Sundry Print Report

Well Name: BIG EDDY UNIT 14 Well Location: T20S / R31E / SEC 14 / County or Parish/State: EDDY /

Notice of Intent

Type of Action: Workover Operations

Schematic - Current Vertical Well Name: BIG EDDY UNIT 14 FEDERAL 001 SWD

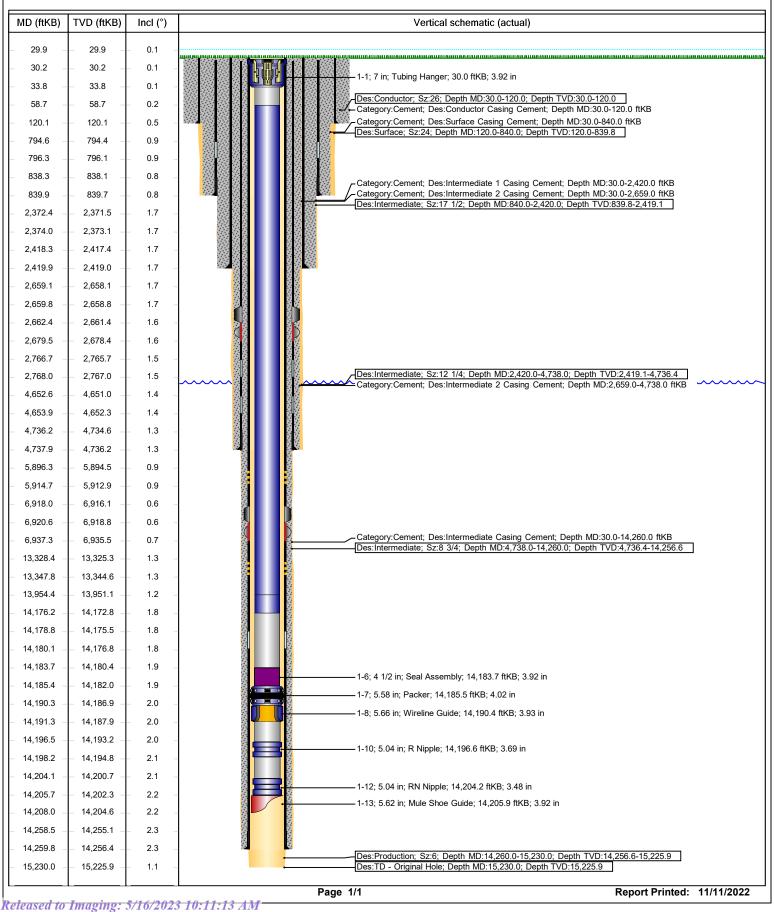
Procedure Description: XTO Permian Operating LLC respectfully submits a NOI to workover the above SWD well to repair the suspected hole in tubing (HIT).XTO will pull the tubing and then test the casing and packer. If they test good we will run back in with new tubing without moving the packer. If the packer test is not good we will unseat and exchange the packer. At that point XTO will notify the BLM of the change and request that they witness or be on location for setting and testing the new packer. I have attached the procedure along with the WBD for your review.

Crea	ated By	Condition	Condition Date
mg	gebremichael	The conditions for approval is the same tubing size will be replaced and the packer will be set within 100 ft. from top of the open hole or perforation.	5/16/2023
